FILE NO.: Z-10130

NAME: Orndorff #5 – PD-R

LOCATION: 2117/2121 Rock Street

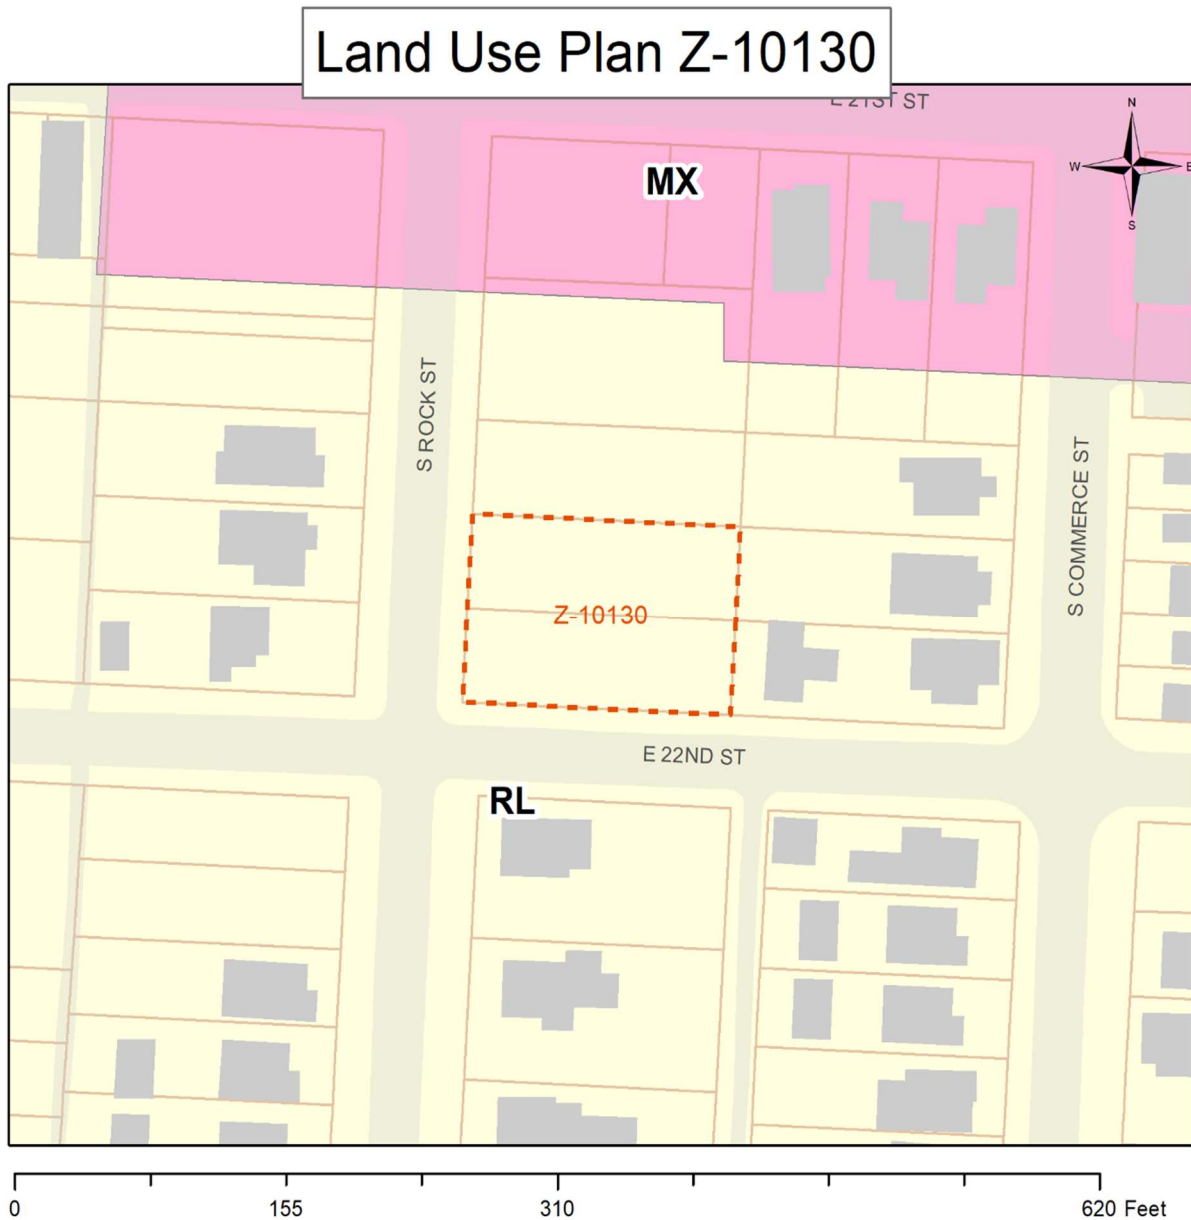
NOTE: No openings allowed with 2' Setbacks from Property Lines.

NOTE: The first floor porch roof encroaches on the ROW and is not allowed to extend past the property line.
